**CALIFORNIA COASTAL COMMISSION**

**RECORD PACKET COPY****Tu 7a****PROPOSED FINDINGS****ON CONSISTENCY DETERMINATION**Consistency Determination No. **CD-117-99**

**FEDERAL AGENCY: CORPS OF ENGINEERS****DEVELOPMENT****LOCATION:**

**DEVELOPMENT****DESCRIPTION:**Lower Mission Creek flood-control improvements  
(Exhibits 2-9)**PREVAILING****COMMISSIONERS:**Commissioners Dettloff, Allgood, Hart, Lee, McCoy,  
Nava, Woolley, and Chairperson Wan**EXECUTIVE SUMMARY**

# RIPRAP WALL ALTERNATIVE

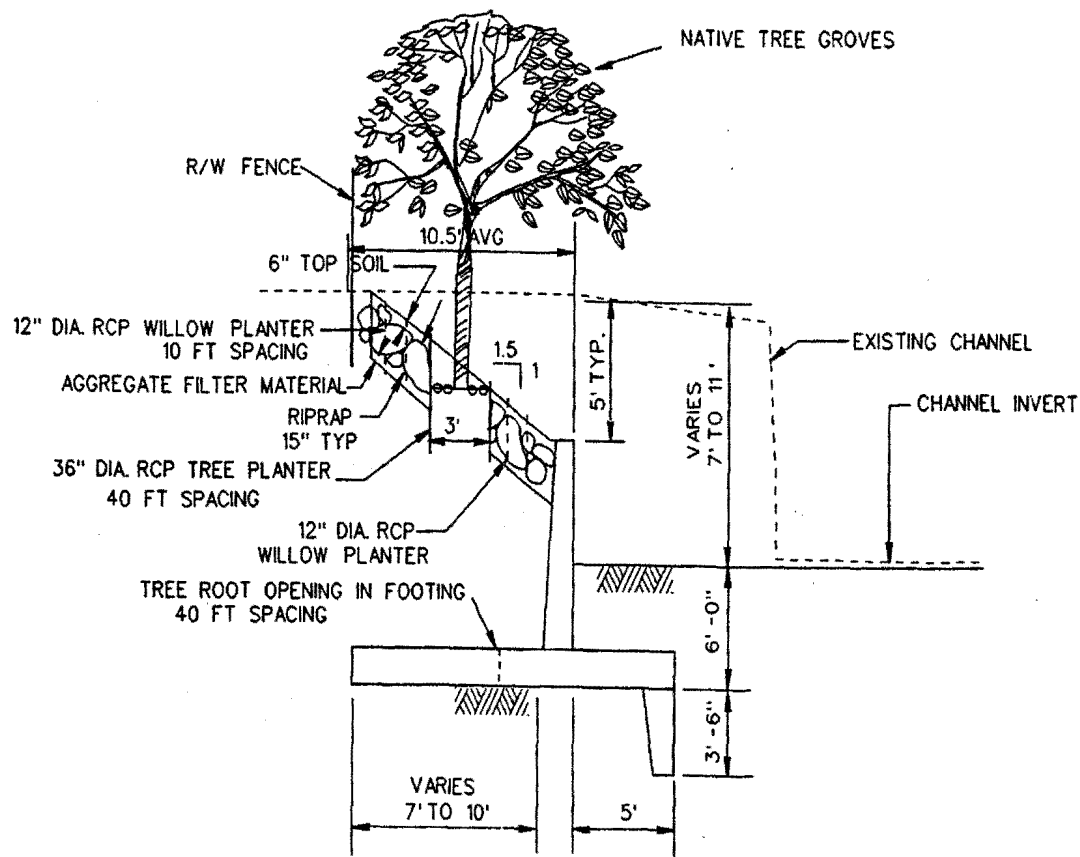
Coastal Commission staff has raised the question of why the U.S. Army Corps of Engineers is not proposing to do either a short vertical wall with vegetated riprap slope above or a full vegetated riprap bank below the Freeway. There are several reasons why this is not being pursued. Alternative 12 (the Preferred Alternative) is projected to cost approximately \$18 million (this includes revisions to reflect the gross appraisal of acquisition costs prepared for the City and changes to the project design to reduce land acquisition costs). Alternative 9, which includes the low vertical toe wall and vegetated riprap above and is the alternative that most closely complies with the California Coastal Commission's request, is even more expensive. For additional information regarding how the Corps calculated real estate costs, as well as additional information on the hydrologic models, we have included a copy of the Technical Appendices for the Main Report (Exhibit 1). There are also additional costs that were not considered in the Corps estimation of costs. These are outlined in more detail below.

b.) *Results and Conclusion.* (See enclosure 1: Table No. E65 and Table No. E66). As shown on Sheet 2 of the drawings, the need for a larger conveyance or cross sectional area and the flatter slope (compared to the stepped wall) would require at least an additional 5 feet of ROW on each side (compared to Alternative 2) of the creek. Given the conservative approach and assumptions applied to this analysis, the project could be expected to cost at least \$15,761,000. This project cost would equate to an annual cost of \$1,118,000 including \$30K for future annual maintenance. Having the same conveyance capacity and level of protection as Alternative 2 in the report, the annual damage reduction benefits that could be expected from this Alternative would be \$995,000. This would yield a Benefit to Cost (B/C) ratio of 0.89. Clearly, this would not meet the Federal requirement for an economically viable (B/C ratio  $\geq 1.0$ ) flood control project and thus, would not warrant Federal involvement. This alternative would have been dropped from further consideration in our feasibility study.

EXHIBIT 1  
42' LMC July Noon  
@ 5 to 10 Years

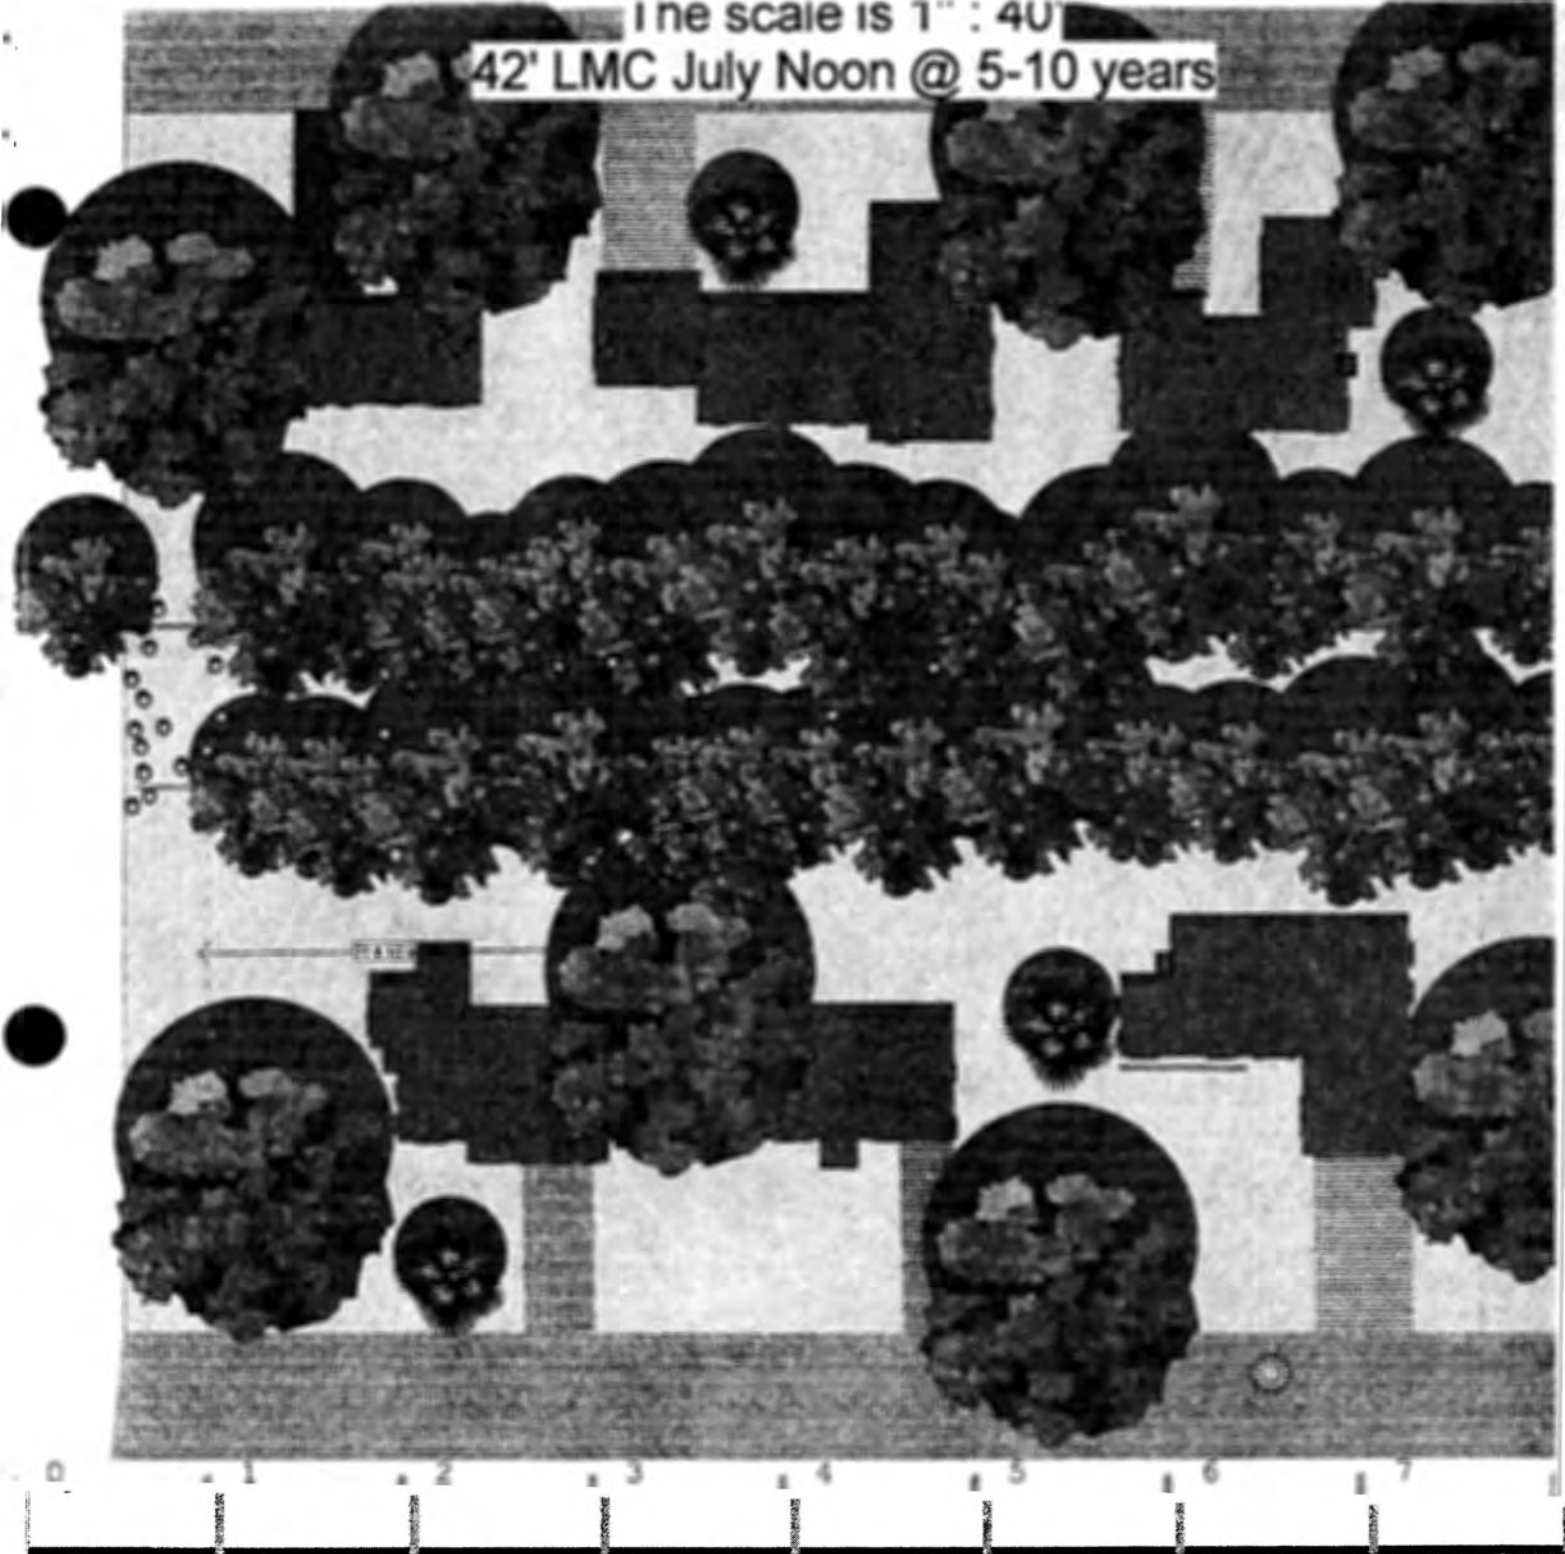
For the section above the freeway, a plan view is attached as Exhibit 1. The plan view is for trees that have grown 5 to 10 years. The view shows the extent of shade produced by these trees in July. Also provided are two 3-D pictures showing the size of the trees in 5 to 10 years (Exhibit 2) and the trees in 20 to 30 years (Exhibit 3). This analysis clearly indicates that the proposed planting of sycamore and willow trees will completely shade
